Roof Safety Report

Mandurah Forum, WA 6210

Prepared By: Safemaster Safety Products
Date: 28 May 2018

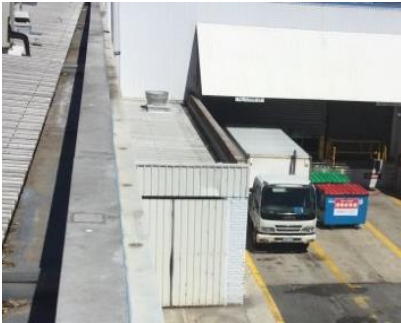
No	Photo of Hazard	Details of Hazard	Details of Risk	Existing/ Immediate Control Measure	Curre nt Risk Level	Proposed Permanent Solution	Resid ual Risk Asse sme nt	Details of Action Taken	Status	Reference
47	Building: General Stores Location Reference: L27 Task: Access to the roof									
		Bottom rung height is less than required minimum and no slip resistance on ladder rungs	Trips, Slips and Falls	Awareness induction	Med	Existing ladder to be removed and new ladder to be installed	Low	Client advised	Outstanding	OH&S REGULATIONS 3.7 AS/NZS 1657-2013 7.4.3.4 & 7.4.3.1
48	Building: General Stores Location Reference: L27 Task: Access to the roof									
		Bottom rung height is less than required minimum and no slip resistance on ladder rungs	Trips, Slips and Falls	Awareness induction	Med	Existing ladder to be removed and new ladder to be installed	Low	Client advised	Outstanding	OH&S REGULATIONS 3.7 AS/NZS 1657-2013 7.4.3.4 & 7.4.3.1

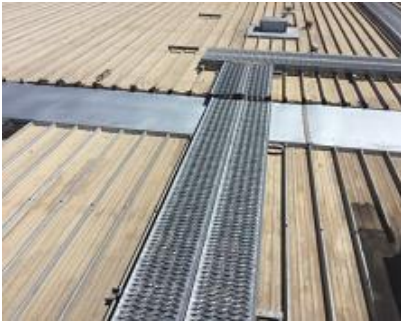
No	Photo of Hazard	Details of Hazard	Details of Risk	Existing/ Immediate Control Measure	Curre nt Risk Level	Proposed Permanent Solution	Resid ual Risk Asse sme nt	Details of Action Taken	Status	Reference
49	Building: General Stores Location Reference: L28 Task: Access to the roof									
		Walkway width is less than required minimum	Trips, Slips and Falls	Awareness induction	Med	Additional walkway sections to be installed	Low	Client advised	Outstanding	OH&S REGULATIONS 3.7 AS/NZS 1657-2013 5.1.3
50	Building: General Stores Location Reference: L28 Task: Access to the A/c units									
		No safe access to the A/c units	Trips, Slips and Falls	N/A	Low	Supply walkway to the A/c units	Low	Client advised	Outstanding	-
